# Union of Concerned Scientists

July 18, 2013

**SUBJECT: Draft Report titled “Consequence Study of a Beyond-Design-Basis Earthquake Affecting the Spent Fuel Pool for a U.S. Mark I Boiling Water Reactor,” [NRC-2013-0136 and ML13133A132]**

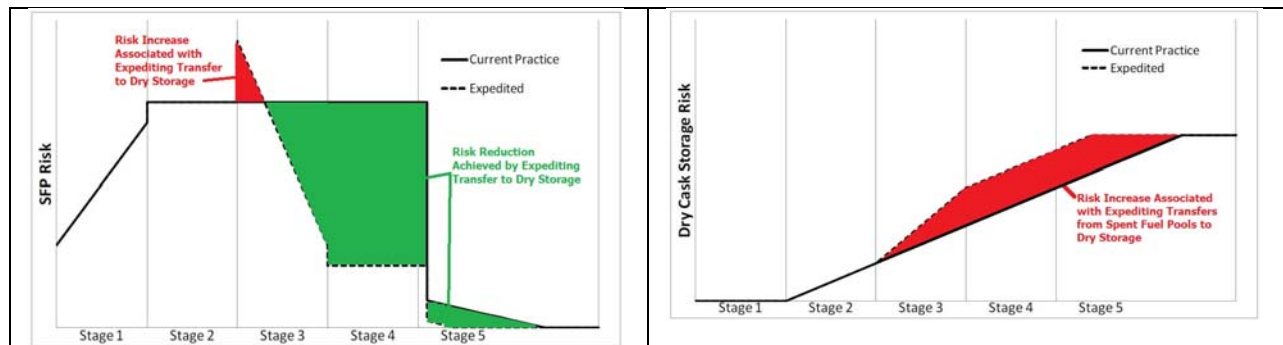
Figure 139 on page B-4 of the draft study (reproduced below with annotations in color added by UCS) represents the risk from irradiated fuel in spent fuel pools and dry storage under both current industry practices and for the proposed expedited transfer from pools to dry storage. The *relative* risk of these two storage options was the real need being served by the study, but the study utterly fails that goal.

UCS generally concurs with the qualitative representation of the relative risks shown in Figure 139 – the spent fuel pool risk declines upon expedited transfers while the dry storage risk is increased.

What UCS expected this NRC study to accomplish was either quantitative assessment of the risks to allow them to be compared or, at a minimum, refinement of the qualitative assessment for that purpose. In other words, UCS expected this study to explain whether the areas in green on the graphs were larger, smaller, or the same as the areas in red.

That was the central question that needed to be answered by the NRC's study – what is the *relative* risk from the two onsite spent fuel storage options. That question remains shamefully unanswered in the study.

This study could have, and should have, provided useful insights to the relative risk of spent fuel pool versus dry storage. The final report must remedy this fundamental flaw.

Figure 52 from the NRC draft study showing the timeline for water draining without mitigation from a high-density spent fuel pool experiencing a moderate leak along a seam between its walls and floor.

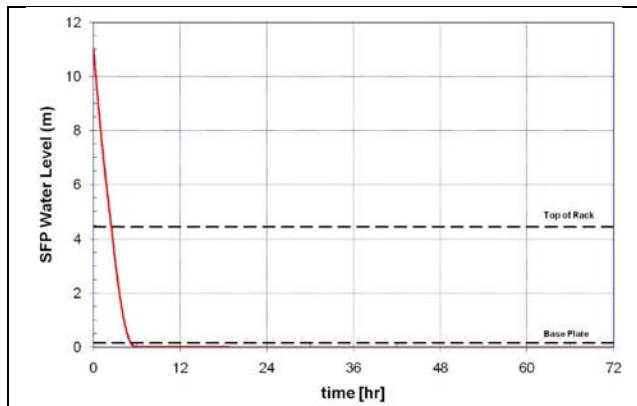
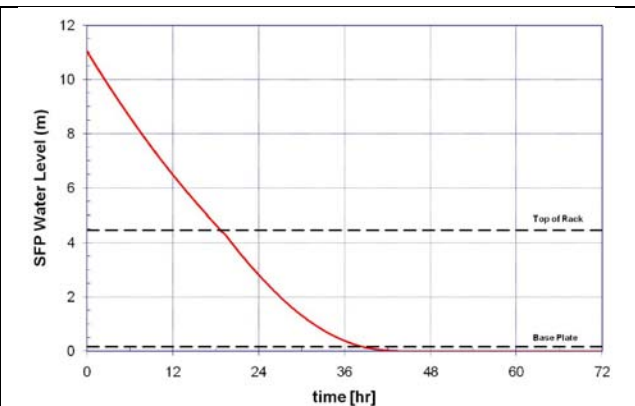
The NRC draft study only examined scenarios that completely drained water from the spent fuel pool. While it may appear that this scenario bounds ones in which only some of the water leaves the pool, this is not the case. Figures 52 and 54 in the NRC draft study (reproduced above) show the spent fuel pool water level during a postulated draining event caused when an extreme earthquake tears along a seam between the pool’s walls and its floor. Figure 52 modeled a moderate leak rate through the tear while Figure 54 modeled a smaller leak from a shorter tear.

In both cases, the leak drained the spent fuel completely. In each figure, dotted lines indicated the top of fuel assemblies in their racks as well as the bottom edge or baseplate of the racks.

The study must consider scenarios other than that involving a 1 in 60,000 year earthquake leading to complete draindown of a spent fuel pool. Just as Three Mile Island demonstrated the fallacy of the large-break loss of coolant shield, the extreme earthquake obsession does not answer all the relevant questions that must be answered.

Figure 53 from the NRC draft study showing the spent fuel assembly temperature rise during the drainage event portrayed in Figure 52 above.

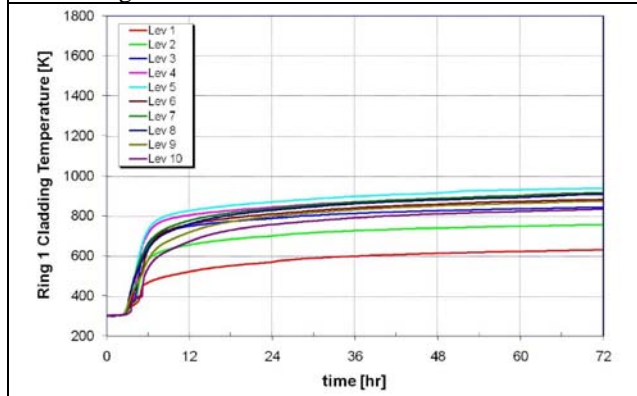
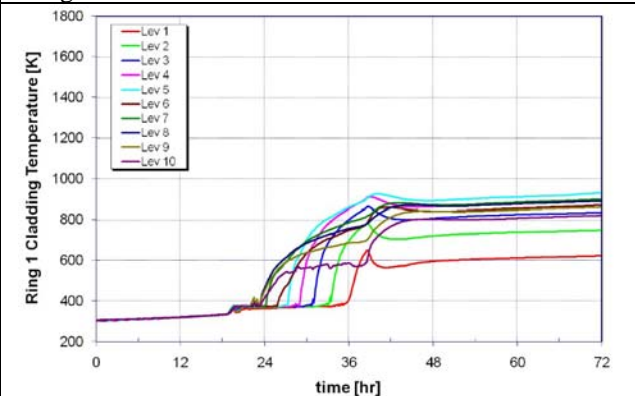
As Figures 53 and 55 in the NRC draft report show, spent fuel assemblies are adequately cooled as long as they are covered with water. As the water level drops below the top of the assemblies, their temperatures begin rising due to insufficient cooling. But once the water level drops below the baseplate, the temperature rise is halted because now air flow by the chimney effect can cool the spent fuel. It's not as effective as water cooling under normal conditions, but it's better than the cooling performed by water and water vapor when the fuel assemblies are only partially

uncovered. Figure 55 clearly shows this phenomenon – the spent fuel assemblies temperatures rise as they become more and more uncovered and then drop after the baseplate is uncovered and air cooling picks up.

But what if a spent fuel pool only partially drains? In that case, the temperature rise is not checked (as shown in Figure 53) or turned around (as shown in Figure 55). Thus, a partially drained spent fuel pool represents a greater hazard than a fully drained one. Again, the NRC draft study opted for the better of these two choices to consider.

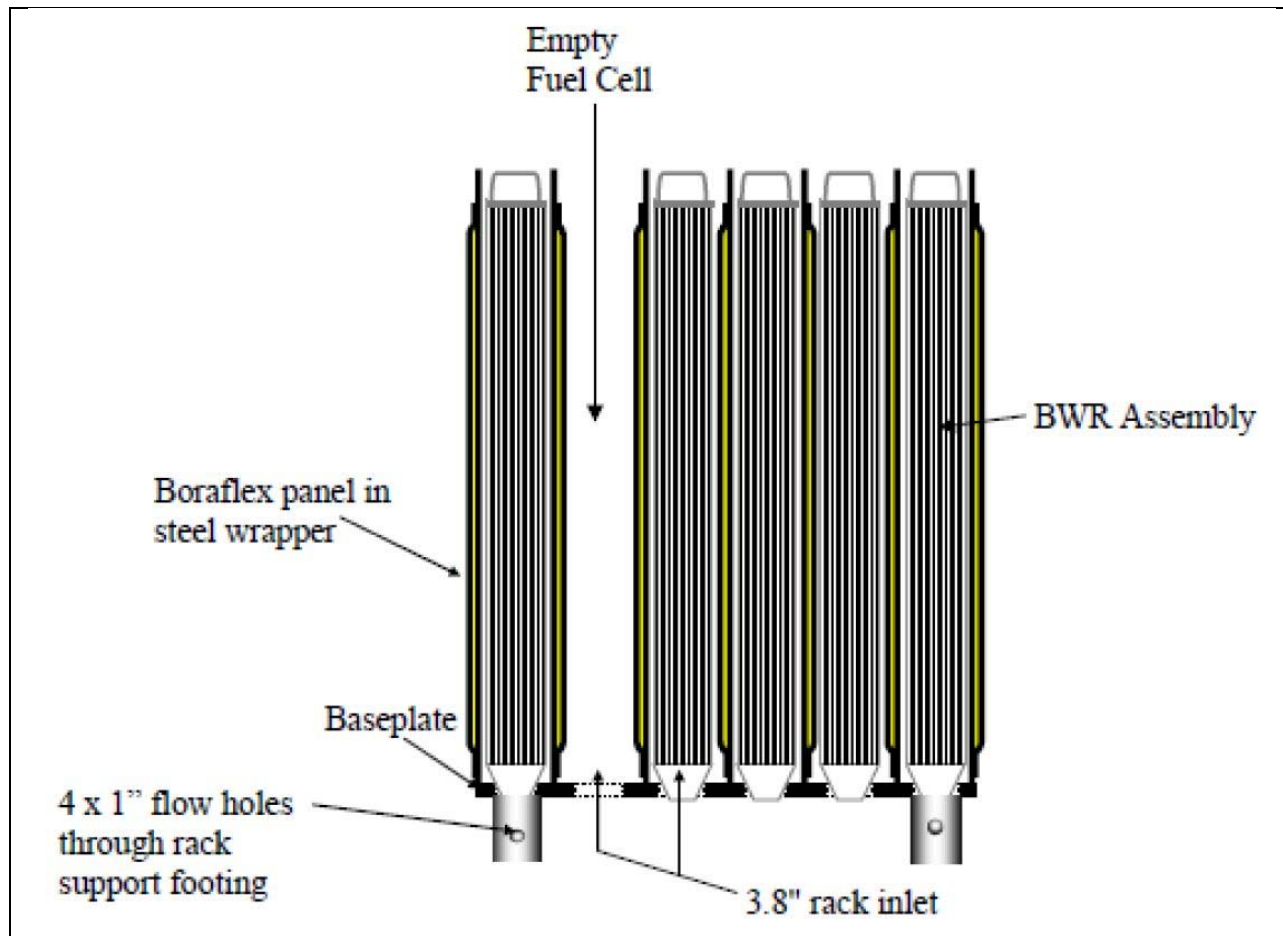
The illustration above is part of Figure 39 in the NRC draft study. It shows a typical storage rack in a BWR spent fuel pool. The little white saucer-like items on the bottom of each fuel assembly are nosepieces – the conical metal ends of a fuel assembly. The nosepieces fit into holes in the spent fuel storage racks and earlier in holes inside the reactor core. The nosepieces have holes that allowing cooling flow through the fuel assembly. The storage racks have feet that keep the nosepieces several inches off the floor of the spent fuel pool. This arrangement allows cooling water to flow down and under the racks and move upwards through the spent fuel assemblies. If the pool is completely drained of water, it also allows air to flow down, under, and up through the spent fuel assemblies.

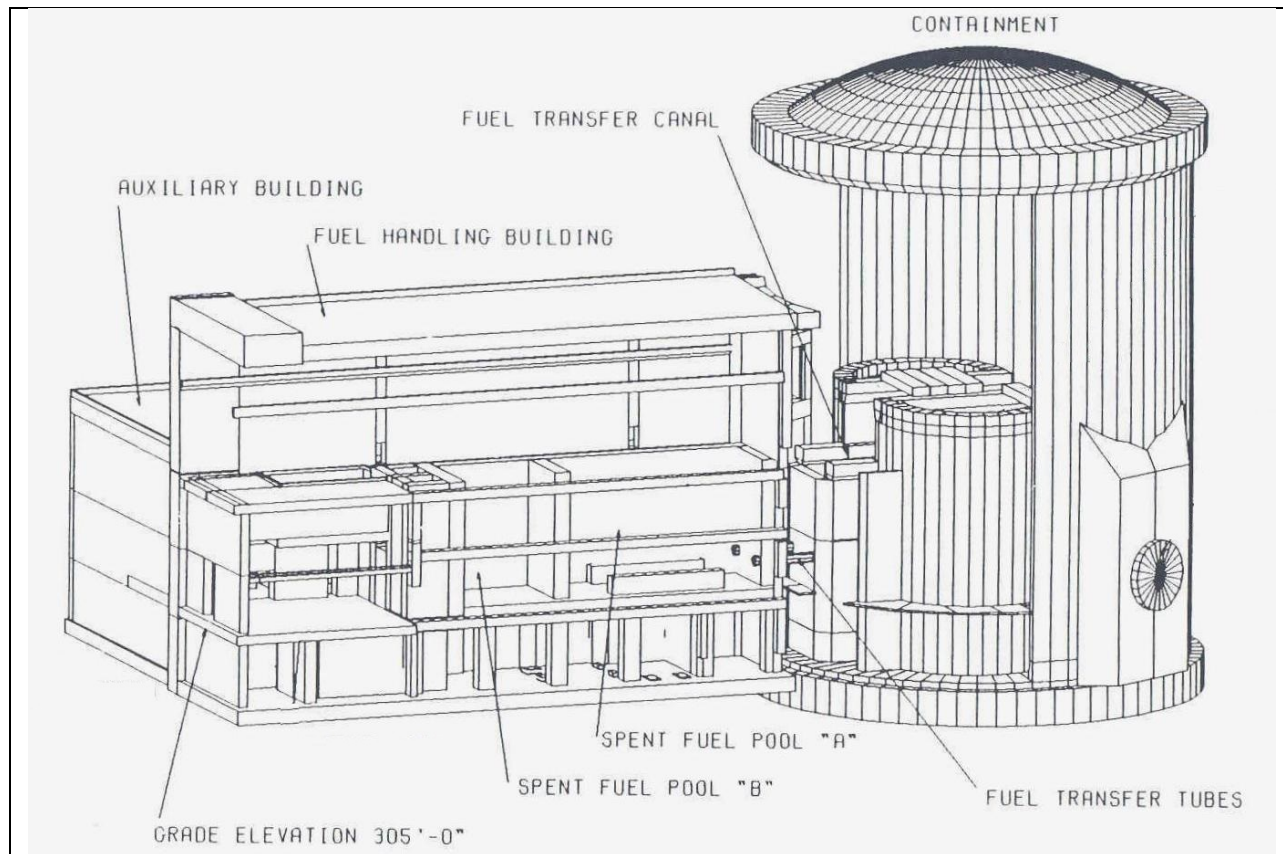
Page 11 of the draft study states “The conditional probability of a Zircaloy cladding fire given a complete loss of water was found to be 1.0 for PWRs [pressurized water reactors] and 0.25 for BWRs [boiling water reactors] in high-density configurations based on differences in assumed rack geometry.” A 1.0 conditional probability means that there’s a 100 percent chance of a PWR spent fuel pool fire if it lost water. (Conditional probability literally cannot get any higher than that, yet it’s curiously been omitted from the draft study.) While BWR spent fuel pools might arguably be more vulnerable to water inventory losses, PWR spent fuel pools are by no means invulnerable. The “in-ground” configuration for PWR spent fuel pools is a fanciful notion lacking literal and figurative foundation, as shown below..

For example, and not a unique one, the figure above is a 3D drawing of a pressurized water reactor currently licensed to operate in the United States. The floor of the spent fuel pool is not embedded in the ground – there is open space within the fuel handling building that could accommodate the water rushing from a tear along the spent fuel pool wall to floor joint.

In this, and too many other instances, when faced with multiple choices, the NRC picked a non-conservative, non-bounding option. If the choices were made so as to model realistic versus worst-case conditions, that'd be one thing. But the choices seem made so as to model best-case versus realistic conditions. In this specific instance, the NRC must either examine a PWR spent fuel pool scenario in its final report or justify excluding a 100 percent conditional probability of fire along with its disastrous consequences.
